Re: Florida Power & Light Company
Proposed Turkey Point Units 6 and 7
Docket Nos. 52-040 and 52-041
Supplemental Response to NRC Request for Additional Information Letter No. 72
(eRAI 6985) SRP Section 11.02 - Liquid Waste Management Systems

NRC RAI Number: 11.02-6-6 (eRAI 6985)

RAI Questions on Proposed Deep Well Injection Disposal Method

Figure 1 – Proposed Locations of Deep Injection Wells and Dual Zone Monitoring Wells

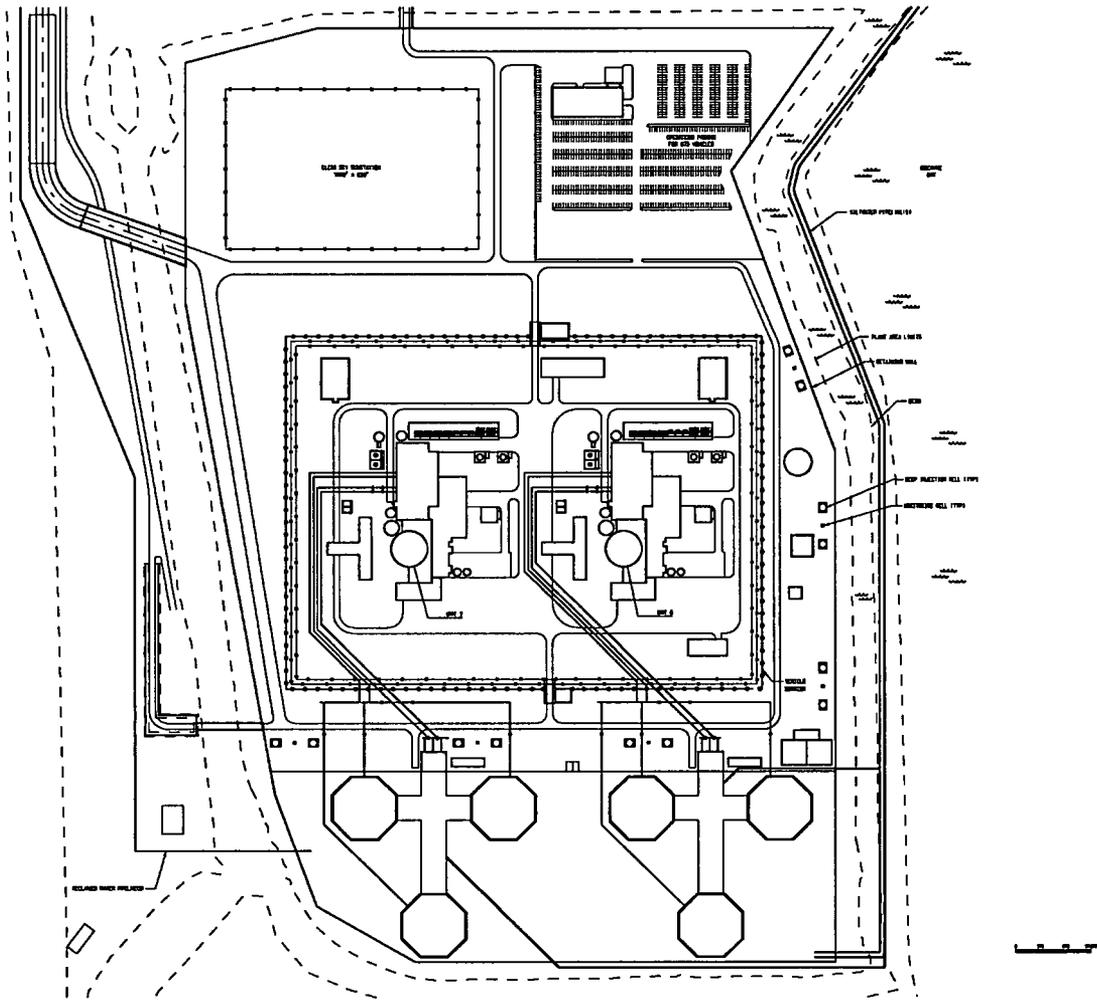
With respect to injection flow and dilution flow rates, the applicant is requested to reconcile differences in stated flow rates and citations for the location of such information. For example, FSAR Tier 2, Rev. 4, Section 11.2.3.5 refers to FSAR Section 9.2.6.2.1 for details on deep well injection, but this FSAR section addresses the treatment of sanitary wastes. While FSAR Tier 2, Rev. 4, Section 11.2.3.5 identifies dilution flow rates for the disposal of liquid effluents by deep well injection in assessing radiological impacts, it does not refer to a specific FSAR section for design specific information, such as FSAR Tier 2, Section 9.2 or 10.4.5. A review of ER, Rev. 4, Section 5.2.3.2.4 indicates that the stated flow rates are 12,500 gpm and 58,000 gpm, which are consistent with ER Rev. 4, Table 3.3-1 under normal and maximum cases. However, FSAR Rev. 4, Section 2.4.12.2.1.3 refers to peak and operational injection rates, with a stated 14,000 gpm for reclaimed water and 62,500 gpm for seawater as implied normal operational flow rates. These injection rates are driven, in part, by FLDEP specifications on maximum linear velocities and friction loss and injection pressures, but such details and limitations on the design basis are not described in the FSAR. Accordingly, it is not

There are two sources of makeup water for the circulating water system (CWS) – reclaimed water (primary) and saltwater from the radial collector wells (backup). The saltwater backup source is expected to be used not more than 60 days in any consecutive 12-month period. The saltwater backup source will be used only when the primary water source is not of sufficient quality or quantity. The deep injection well flow is comprised of the blowdown from the cooling tower circulating water system, additional dilution from the Reclaimed Water Treatment Facility (primary source only), and discharge flow from the sanitary waste treatment plant and wastewater retention basin during normal plant operation. Figure 1 depicts the proposed locations of the deep injection wells and dual zone monitoring wells.
